Consumers
Power
Company

MIDLAND ENERGY CENTER
MIDLAND DOCKET NOS 50-329, 50-330
NRC REQUEST FOR ADDITIONAL INFORMATION ON THE
SEISMIC MARGIN REVIEW REPORT
FILE B3.7.1 SERIAL 29815

ATTACHMENT RESPONSE TO NRC QUESTIONS ON VOLUME VII OF CONSUMERS
POWER COMPANY SEISMIC MARGIN REVIEW REPORT

RESPONSE TO NRC QUESTIONS ON VOLUME VII OF
CONSUMERS POWER CO. SEISMIC MARGIN REVIEW REPORT
DOCKET NOS. 50-329 OM,OL and 50-330 OM,OL

FIGURE 3

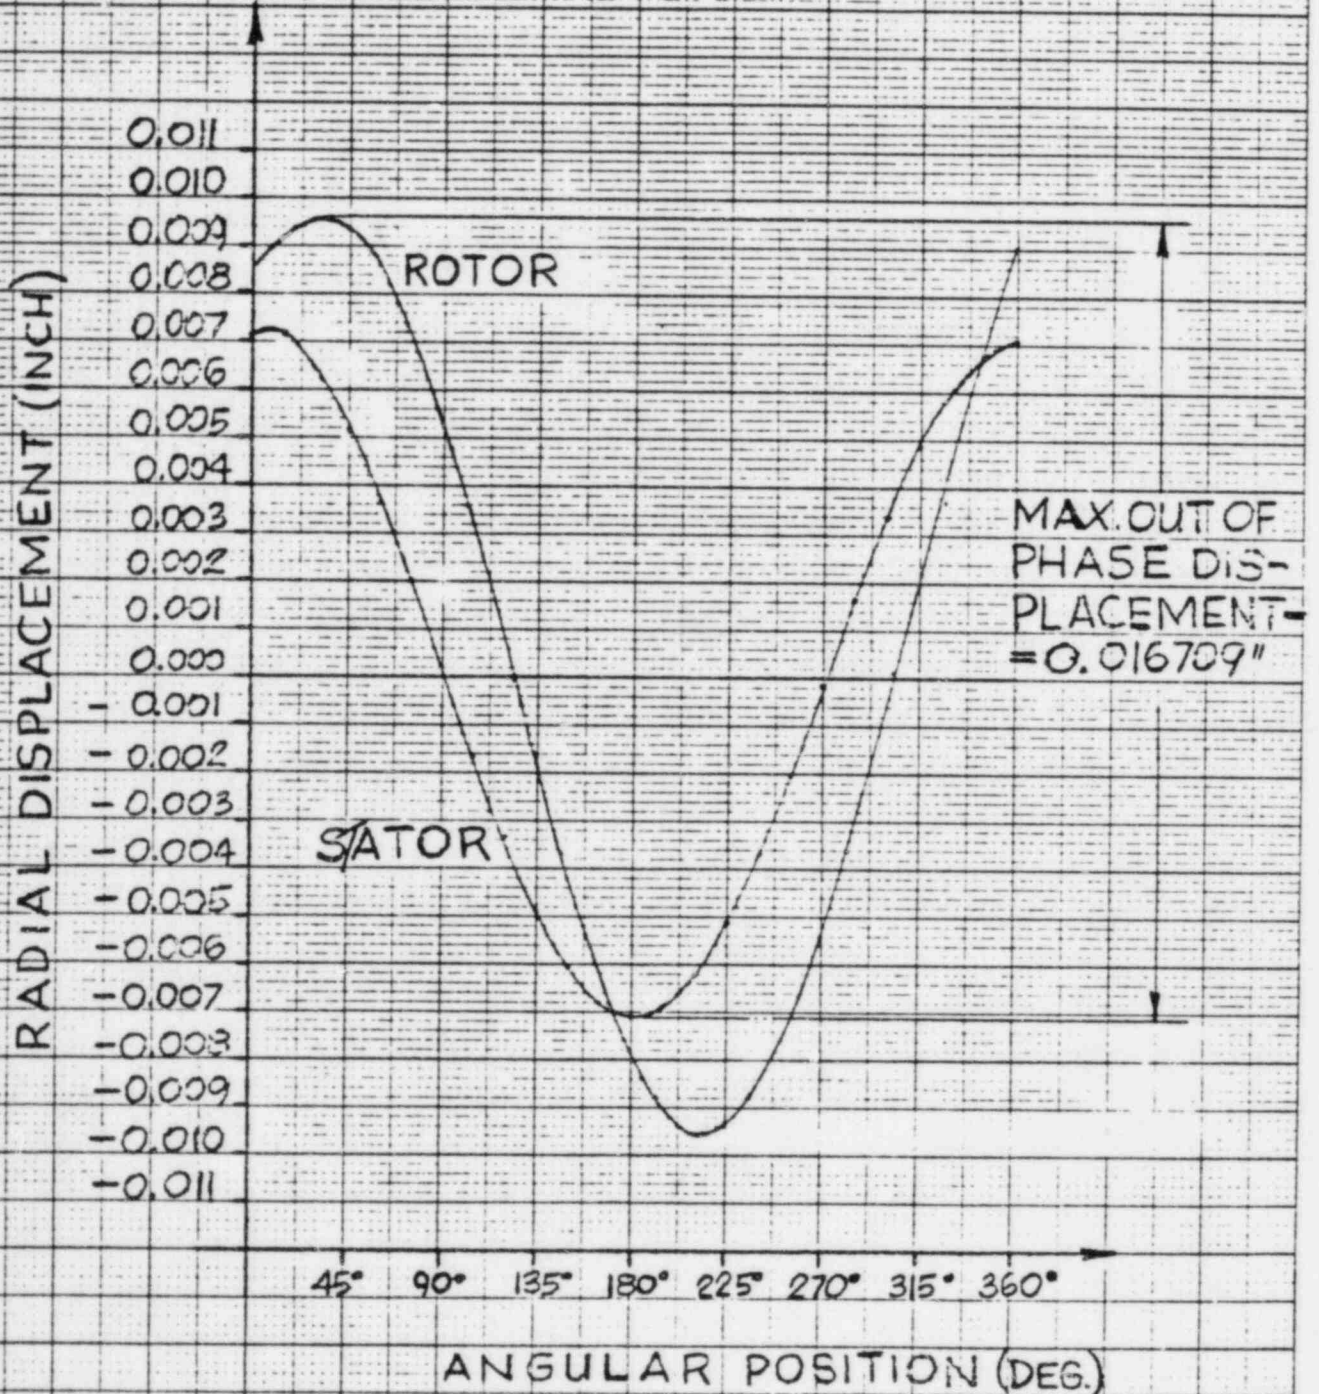
Question (1) Table VII-5-5 Diesel Engine Generator, Part VI. 8.B shows "Max. Critical Deflection" N/A. Explain why this maximum critical deflection was not included, as part of the required assurance of operability.

The Diesel Engine Generator deflection is not the critical SME margin, and was not reported on the basis that only the most critically stressed elements would be addressed. The seismic margin as defined in Volume VII is greater than 21.5.

To illustrate the "SSE" margin, the attached Figure 3 from Delaval Turbine Inc. report 7220-M18-372-1 is attached. From this table, the maximum out-of-phase displacement is 0.0167", while the "air gap" between rotor and stator is stated in the report to be 0.36." Therefore:

$$S.F. (SSE) = \frac{0.36}{0.0167} = 21.56$$

The SME acceleration was enveloped by the SSE acceleration and the S.F. (SME) would be larger than 21.56.

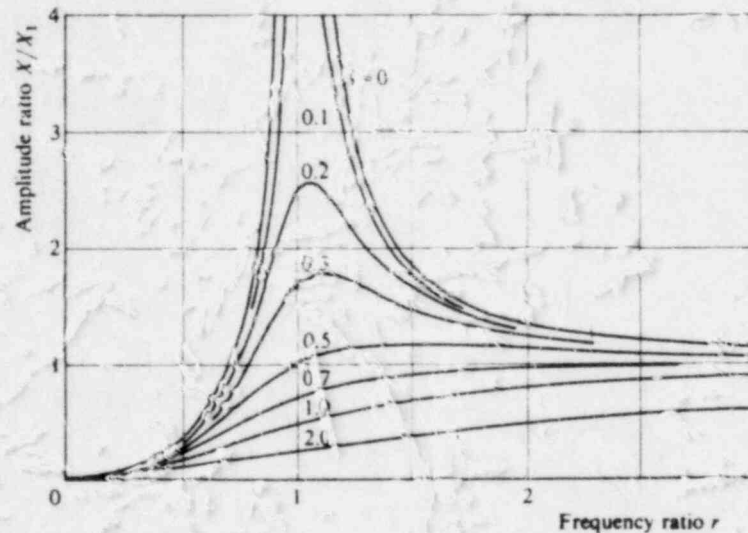
Question (2) Page VII-7-5 states:

"The TRS do not completely envelope the SME spectra in the low frequency regions. See Appendix A, Figures VII-A-9-1 through VII-A-9-3. The unenveloped regions of the SME spectra have negligible effects on the total response of the cabinet because the cabinet fundamental frequencies are at least 1.5 times higher than the unenveloped frequencies of the SME spectra. In conclusion, the cabinet and instruments are considered qualified for the SME."

The test, for these cabinets, is described in Appendix A, Table VII-A-9 as multi-axis and multi-frequency. Figure VII-A-9-3 presents the seismic spectra for the side-side/vertical axes of excitation for SME and TRS spectra. This figure shows at the fundamental side-side frequency for the sensor cabinet (6.1 Hz) and the FCCAS cabinet (8.1 Hz), the SME is 1.88 and 2.38, respectively, greater than the TRS accelerations. Clarify the above statement to account for the multi-axis aspect of this test versus the single axis presentation.

As an example, refer to the SME vertical response spectrum plot, Figure VII-9-3. The spectrum shows that although the SME contains significant low frequency motion in the vertical direction, the vertical response of an oscillator with a frequency (vertical) of 35.0 Hz will show only minor amplification. This point is further illustrated by the figure below taken from Mechanical Vibrations, Tse, Morse & Hinkle, 1964.

The figure shows the steady-state response amplification of a single degree-of-freedom oscillator subjected to a harmonic base motion. The frequency ratio, r , is the ratio of the oscillator natural frequency to the forcing function frequency. For the cabinet in question here, the ratio of the vertical fundamental frequency to the frequency at which the SME spectrum is first unenveloped is 3.1. From the figure, it is seen that at a frequency ratio of 3.1, response amplification is negligible. Thus, it can be concluded that the low frequency vertical motion in the SME has negligible importance, and the fact that the SME is not enveloped in this region does not present a qualification concern. Any contribution to the vertical response from this low frequency motion could, therefore, only arise if the horizontal modes (6.1 and 10.7 Hz) have coupled vertical response with large mass participation factors. Large amounts of coupling between horizontal and vertical axes does not exist as demonstrated by the qualification tests.

FIGURE 1. FLOOR RESPONSE SPECTRUM - AUXILIARY BUILDING, ELEVATION 584' -0", EAST-WEST DIRECTION, 1977 MIDLAND PLANT UNITS 1 & 2, 1.0% DAMPING

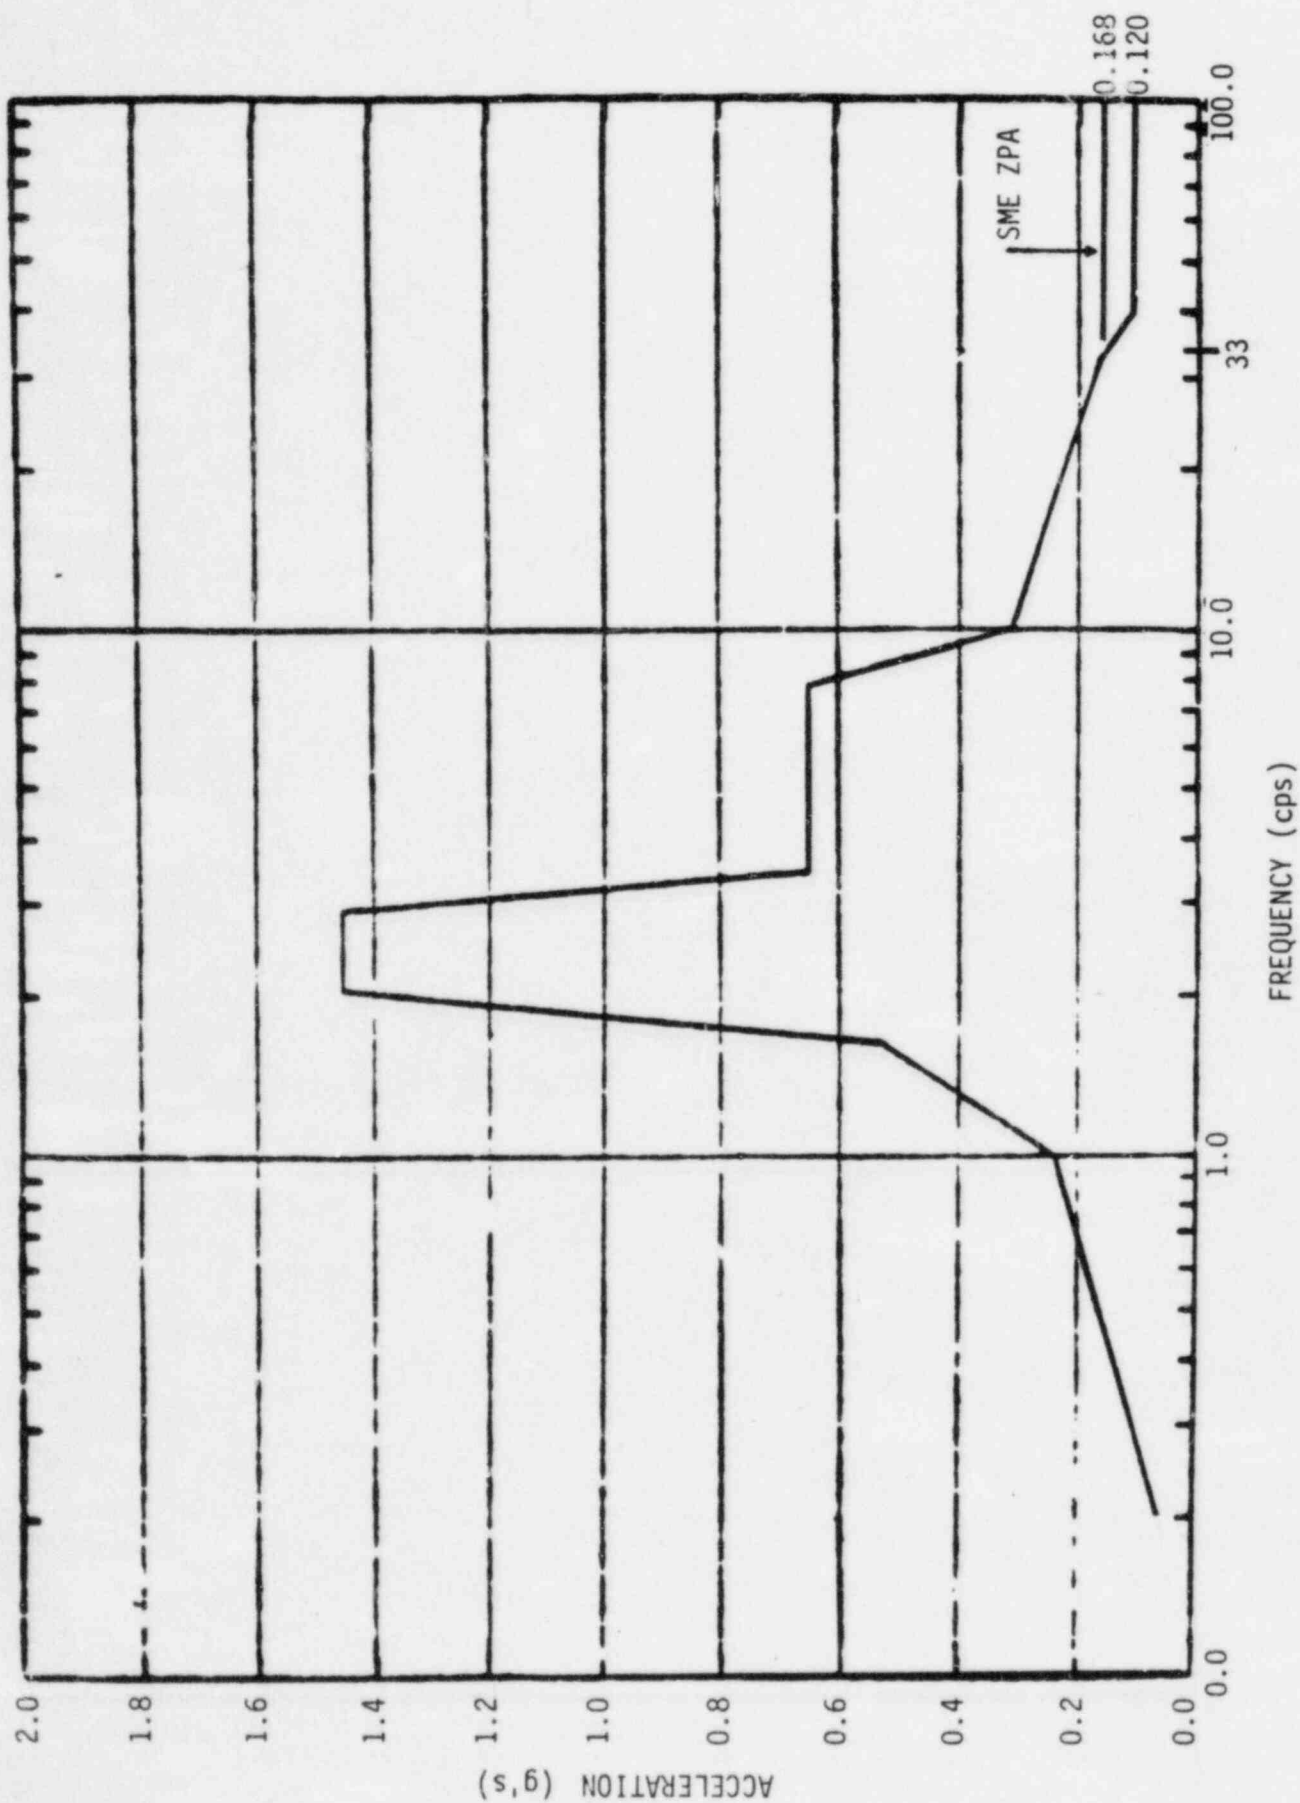
Question (6) Page VII-8-9 for Section 8.7 (Aux. Feedwater Pump - Electric Motor Driven) states: "The SME ZPA's were greater than the design ZPA's in both horizontal directions but were less than the design ZPA in the vertical direction", and for Section 8.8 (Aux. Feedwater Pump - Turbine Driven) states: "The design zero period accelerations in the horizontal directions were less than the corresponding SME accelerations, but the vertical design acceleration was greater than the vertical SME acceleration." Since both of these pumps are located in the Auxiliary Building at Elevation 524'-0", explain why there is a difference in these two statements and present the appropriate horizontal and vertical seismic spectra.

The two statements are the same, although the wording is structured differently, i.e., design ZPA greater than SME ZPA is the same as SME ZPA less than design ZPA. The horizontal and vertical spectra comparisons are enclosed as requested, Figures 1 through 3. Only the ZPA comparisons are made as the pump was determined by analysis to be rigid.
